**From:** Doug Clough  
**Sent:** Friday, January 26, 2018 9:10 AM  
**Subject:** ShoreLand'r Pontoon Bunk Fastener Bulletin  
**Attachments:** PONTOON LAG BOLT INSTRUCTION.pdf

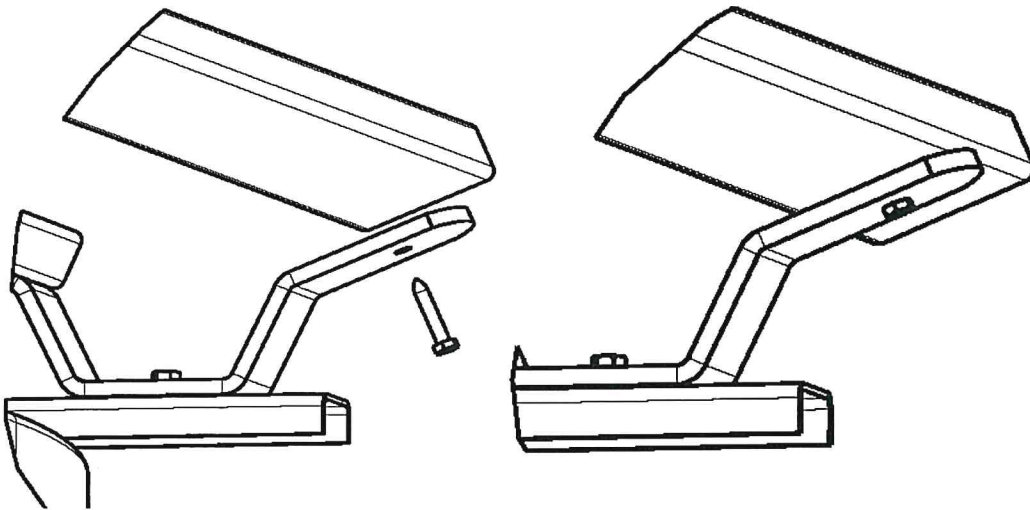
Our pontoon trailer bunks are being shipped with a new lag bolt.

This is a longer, more robust bolt with a lag-type thread, resulting in deeper penetration and a more aggressive hold.

This change is due to reports in the field of bunks loosening during dry loading.

Even with this improved lag bolt, it's imperative that this fastener be applied as straight as possible per the attached instructions.

**New Lag Bolt for Pontoon bunks.** This should be inserted as straight as possible which will improve the bolts ability to hold the bunks more securely. By doing this will give the lag bolt better holding strength by creating more even contact between the components with the head of the lag bolt flat against the bracket.
